**COUNTY OF WESTCHESTER
NEW YORK
DIVISION OF ENGINEERING**

**ADDENDUM NO. 5
CONTRACT NO. 20-530**

**Infrastructure Rehabilitation – Phase 2
Playland Park
Rye, New York**

WESTCHESTER COUNTY DEPARTMENT OF PUBLIC WORKS
CONTRACT 20-530
INFRASTRUCTURE REHABILITATION PHASE 2
ADDENDUM NO. 5
AD-PR-S-01
7/19/2021

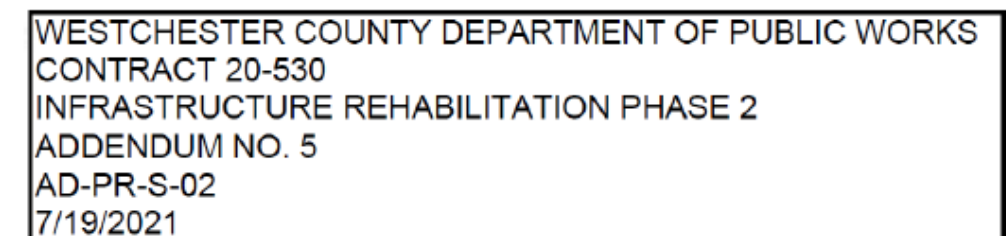
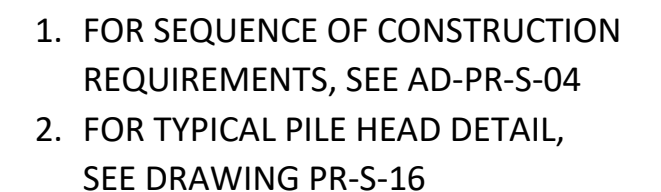
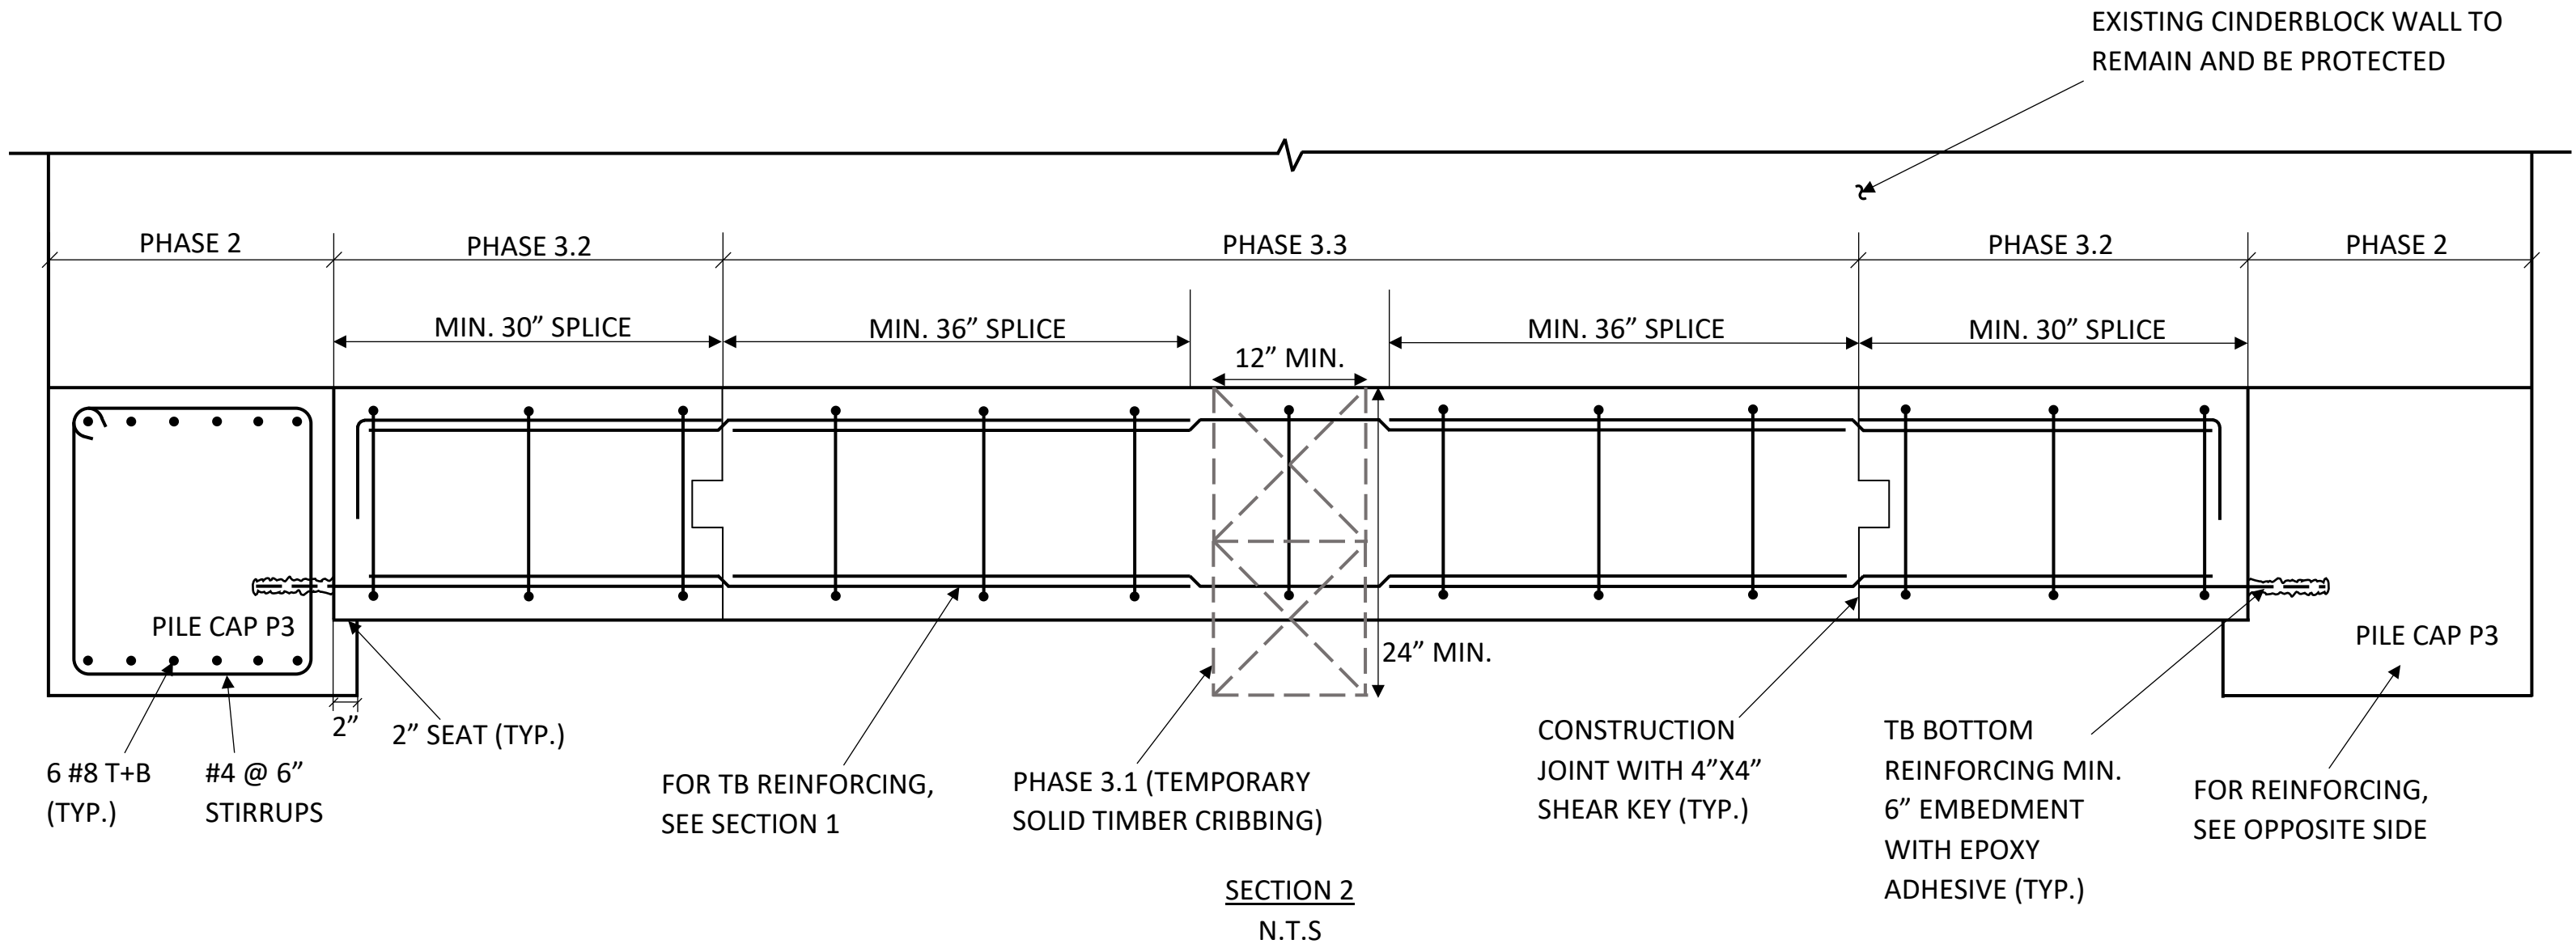
- Item 3:** Drawing PR-S-07, Sheet 121 of 288, *Plaza Restaurant – Structural Foundation Plan*.
Modify “Foundation Plan” as shown on Addendum Drawing AD-PR-S-01.

1. FOR SEQUENCE OF CONSTRUCTION REQUIREMENTS, SEE AD-PR-S-04

WESTCHESTER COUNTY DEPARTMENT OF PUBLIC WORKS
 CONTRACT 20-530
 INFRASTRUCTURE REHABILITATION PHASE 2
 ADDENDUM NO. 5
 AD-PR-S-03
 7/19/2021

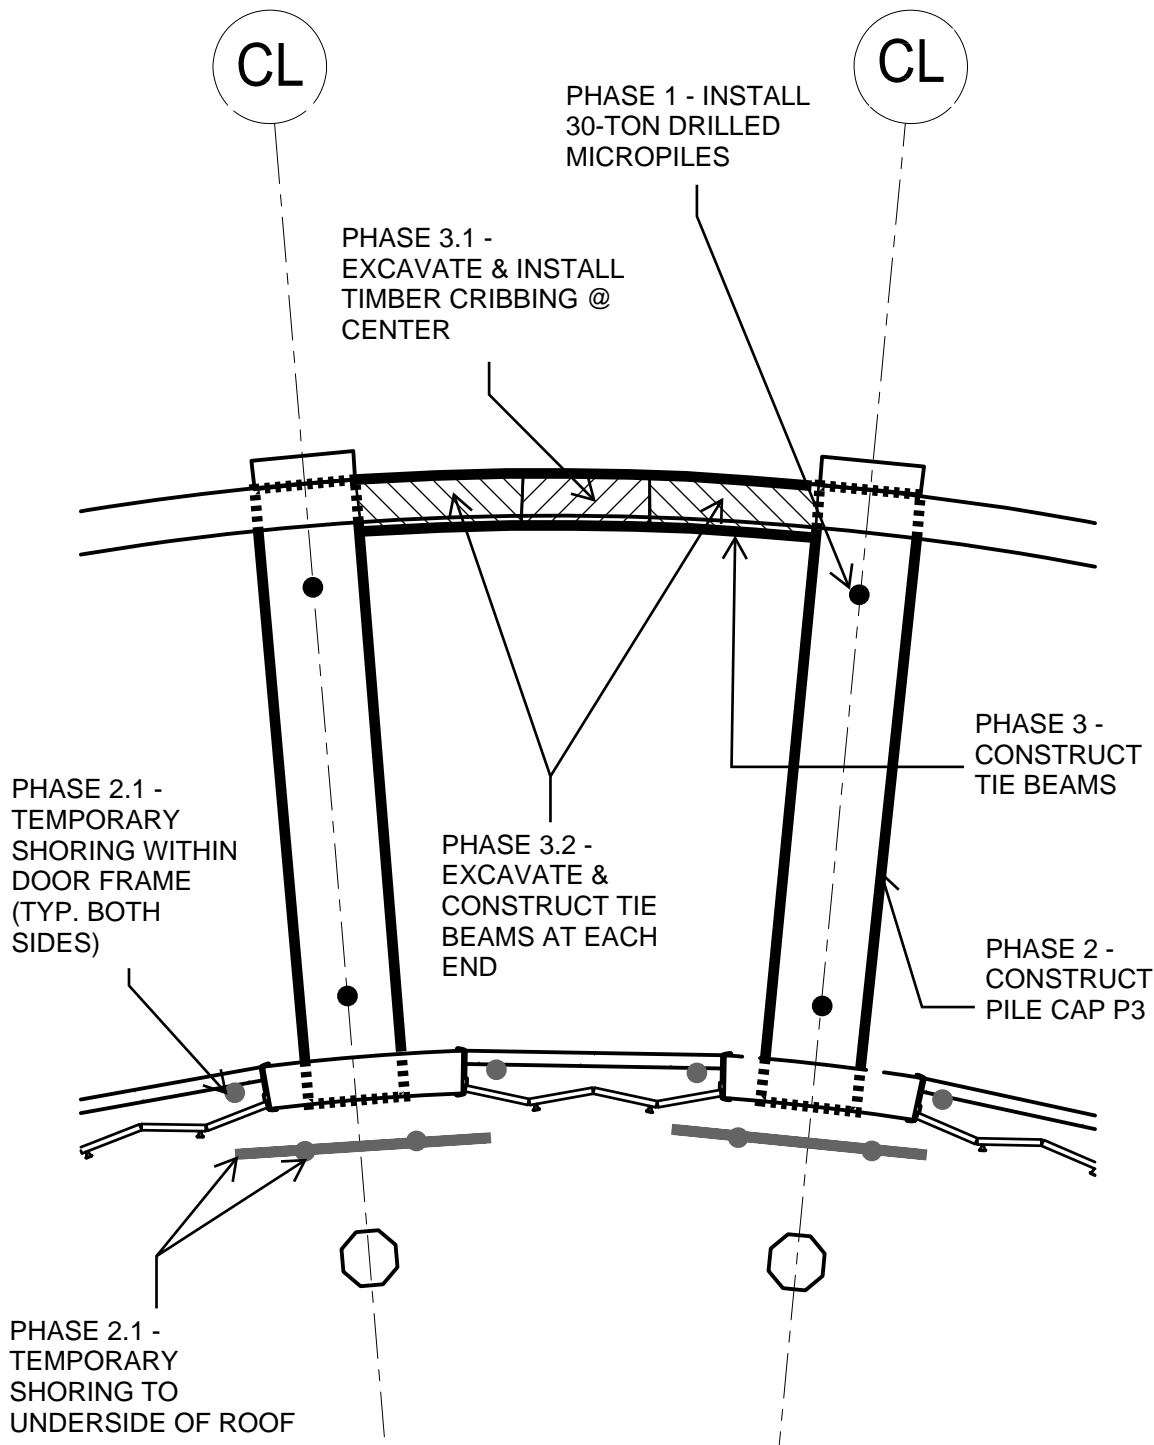
- Item 4:** Drawing PR-S-14, Sheet 128 of 288, *Plaza Restaurant – Sections and Details*.
Insert Section 1 as shown on Addendum Drawing AD-PR-S-02.
- Item 5:** Drawing PR-S-14, Sheet 128 of 288, *Plaza Restaurant – Sections and Details*.
Insert Section 2 as shown on Addendum Drawing AD-PR-S-03.

CONTRACT No. 20-530
SHEET No. 1 OF 1
DATE: July 19, 2021
NOT TO SCALE
DRAWING No.
AD-A-02

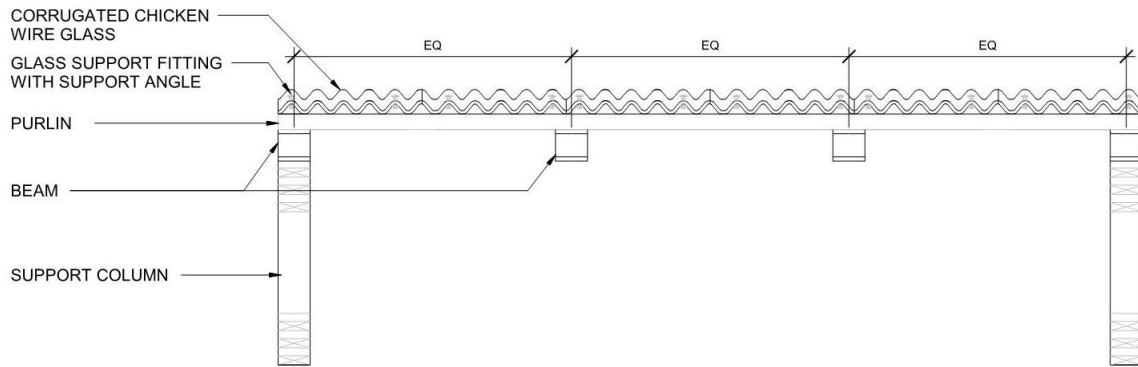
- Item 7:** Drawing PR-A-61 (Page 108), Door & Hardware Schedule.
Modify the Contract drawing as shown on Addendum Drawing AD-A-01, attached.
- Item 8:** Drawing BCR-A-61 (Page 249), Door & Window Schedule and Transition Details.
Modify the Contract drawing as shown on Addendum Drawing AD-A-02, attached.

5	None of the tags shown on the Bumper Car Restroom door schedule have been assigned hardware sets. This was not addressed in Addenda #3. Please advise	<i>See attached AD-A-02</i>
6	Drawing PR-A-11 , keynote 87 required FRP wall covers and accessories, please provide specifications.	<i>See attached Specification 06 83 16 - Fiberglass Reinforced Paneling</i>
7	Drawing Sheet PR-A-62. Are window Types A1 and A2 to be furnished with Specification Section 085123? Or are these Ornamental Grilles per Section 3/PR-A-54?	<i>Window Types A1 and A2 to adhere to Specification Section 08 51 23 – Steel Windows. See detail 1/PR-A-62</i>
8	Drawing Sheet BCR-A-61. Are window Types W1 and W2 to be furnished with Specification Section 085123?	<i>Window Types W1 and W2 to adhere to Specification Section 08 51 13 – Aluminum Windows</i>
9	Specification Section 085123, Section 2.2, Letter B “Simulated Divided Lite Muntins.” Interior and exterior applied muntins are noted to be hot rolled steel. Can they be furnished as aluminum muntins? This is typical to make sure the VHB tape adheres them to the glass	<i>Aluminum muntins may be provided.</i>

DOOR NUMBER	LOCATION	DOOR PANEL							DOOR FRAME							HARDWARE SET	REMARKS
		PANEL TYPE	WIDTH	HEIGHT	THK	MATERIAL	FINISH	GLASS	FIRE RATED	FRAME TYPE	MATERIAL	FINISH	HEAD	JAMB	THRESHOLD		
1	GROUND FLOOR	D	3'-0"	7'-0"		HM	PAINTED	-		1	HM	PAINTED	H1	J1	2	HS-02	INSULATED DOOR WITH WEATHERSTRIPPING
2	GROUND FLOOR	B	5'-0"	7'-0"		HM	PAINTED	-	45 MIN	2	HM	PAINTED	H1	J1	2	HS-05	(2) 2'-6" WIDTH DOORS
3	GROUND FLOOR	C	3'-0"	7'-0"		WD	PAINTED	-	-	3	WD	PAINTED	H2	J2	2	HS-03	
4	GROUND FLOOR	C	3'-0"	7'-0"		WD	PAINTED	-	-	3	WD	PAINTED	H2	J2	2	HS-03	
5	GROUND FLOOR	A	3'-0"	7'-0"		WD	PAINTED	-	-	1	HM	PAINTED	H1	J1		HS-01	
6	GROUND FLOOR	E	0'-0"	0'-0"				-								-	CASED OPENING.
7	GROUND FLOOR	E	0'-0"	0'-0"				-								-	CASED OPENING
8	GROUND FLOOR	C	3'-0"	7'-0"		WD	PAINTED	-	-	3	WD	PAINTED	H2	J2	2	HS-03	
9	GROUND FLOOR	A	3'-0"	7'-0"		WD	PAINTED	-	-	1	HM	PAINTED	H1	J1	2	HS-02	
10	GROUND FLOOR	A	3'-0"	7'-0"		WD	PAINTED	-	-	1	HM	PAINTED	H1	J1		HS-01

REFERENCE DRAWING: BCR-A-43

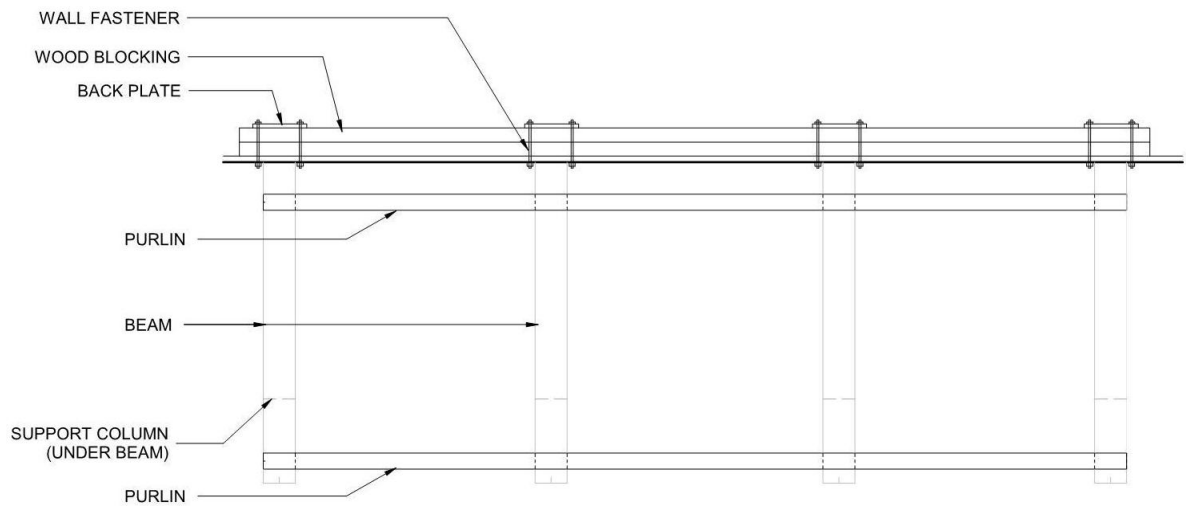
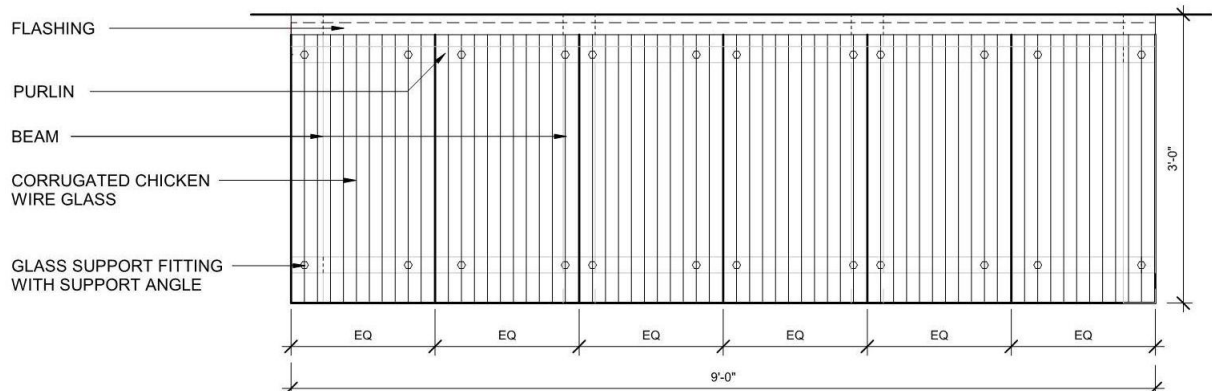
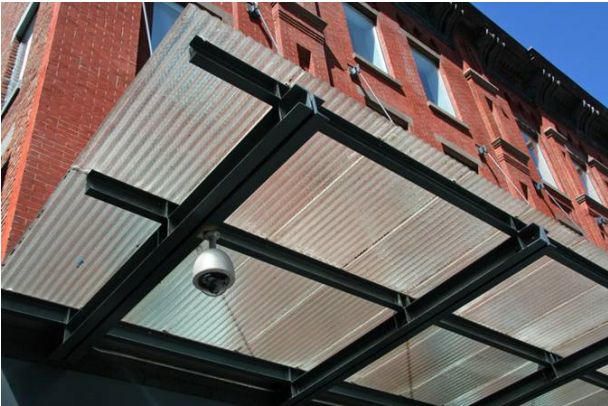
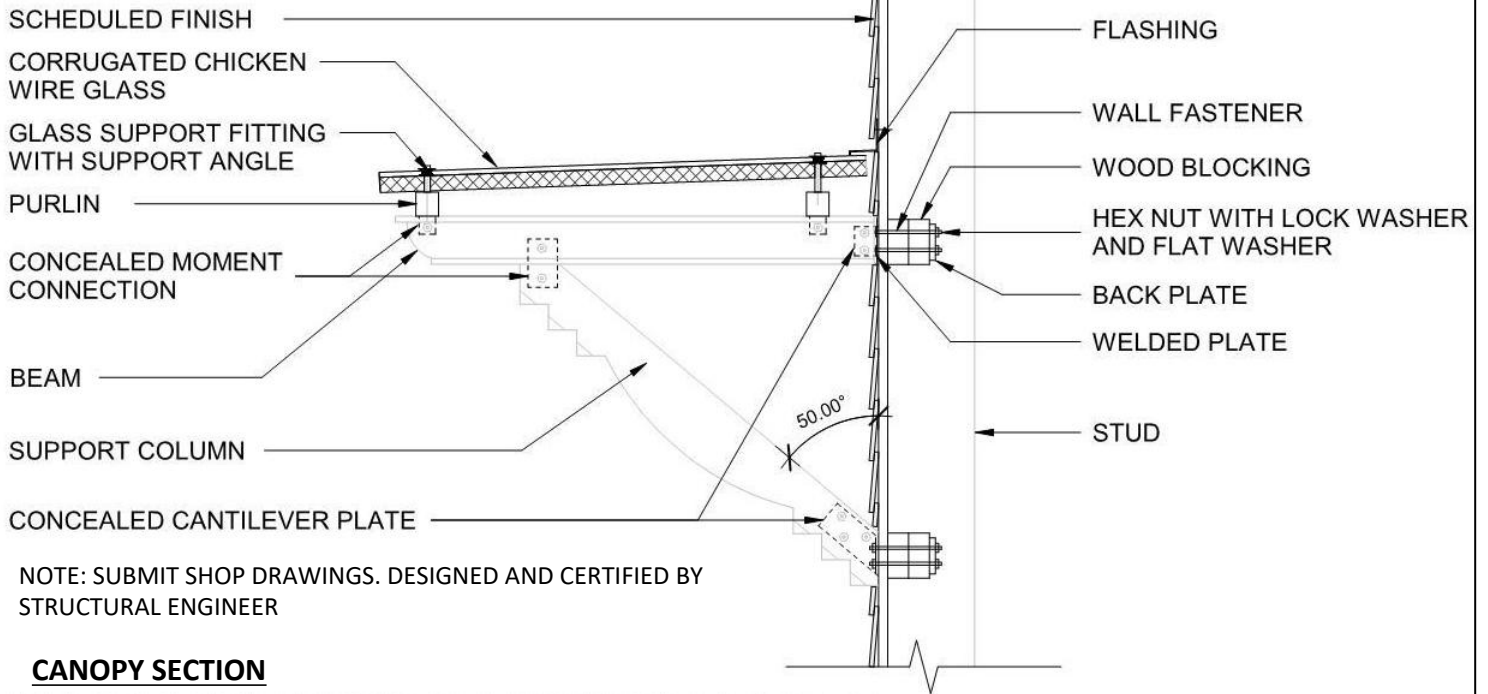
- Item 9:** Drawing BCR-A-43 (Page 245), Interior Elevations.
Insert the Contract drawing as shown on Addendum Drawing AD-A-03, attached.

3	Sheet number PR-A-61 door schedule. All the finishes are listed as TBD. Please advise what finishes are required.	<i>See attached AD-A-01</i>
4	Dr. BCR-A-31, Corrugated Glass canopy. Please provide Manufacture/ BOD /detail.	<i>See attached AD-A-03</i>

NOTE: SUBMIT SHOP DRAWINGS. DESIGNED AND CERTIFIED BY STRUCTURAL ENGINEER
